ECN/PCN No.: M1351

For Manufacturer			
<b>Product Description:</b> MOLDED TYPE POWER INDUCTOR	<b>Abracon Part Number / Part Series:</b> ASPI-0530HI Series	<input type="checkbox"/> Documentation only <input checked="" type="checkbox"/> ECN <input type="checkbox"/> EOL	<input checked="" type="checkbox"/> Series <input type="checkbox"/> Part Number(s)
<b>Affected Revision:</b> A	<b>New Revision:</b> B	<b>Application:</b>	<input type="checkbox"/> Safety <input checked="" type="checkbox"/> Non-Safety

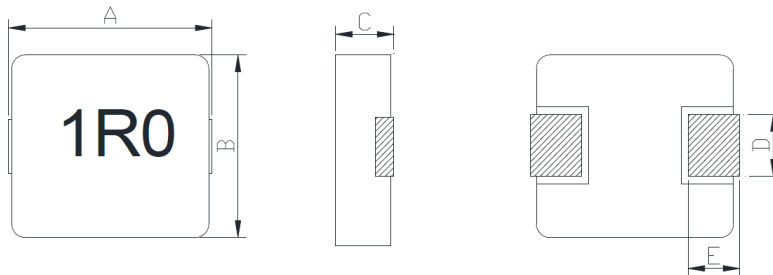
**Prior to Change:**

A	A'	B	B'	L	W	H max
1.0 ±0.4	1.5 ±0.1	2.0 ±0.3	2.5 ±0.2	5.60 ±0.35	5.2 ±0.2	3.0

**After Change:**

A	B	C	D	E
5.7 ±0.30	5.3 ±0.40	3.0 MAX	2.2 ±0.5	1.2 ±0.50

<b>Cause/Reason for Change:</b> Adding Capacity to support the product.		
<b>Change Plan</b>		
<b>Effective Date:</b>	<b>Additional Remarks:</b>	
<b>Change Declaration:</b> The change does not affect the fit or function of the devices in the series. The nominal values and tolerances of some dimensions has been adjusted to reflect the physical dimensions of the acutal parts.		
<b>Issued Date:</b> 4/29/2022	<b>Issued By:</b> Ahmed Alamin	<b>Issued Department:</b> Engineering
<b>Approval:</b> Syed Raza Engineering VP	<b>Approval:</b> Reuben Quintanilla Quality Director	<b>Approval:</b> Ying Huang Purchasing Director
<b>For Abracon EOL only</b>		
<b>Last Time Buy (if applicable):</b>	<b>Alternate Part Number / Part Series:</b>	
<b>Additional Approval:</b>	<b>Additional Approval:</b>	<b>Additional Approval:</b>
<b>Customer Approval (If Applicable)</b>		
<b>Qualification Status:</b>		
<input type="checkbox"/> Approved <input type="checkbox"/> Not accepted
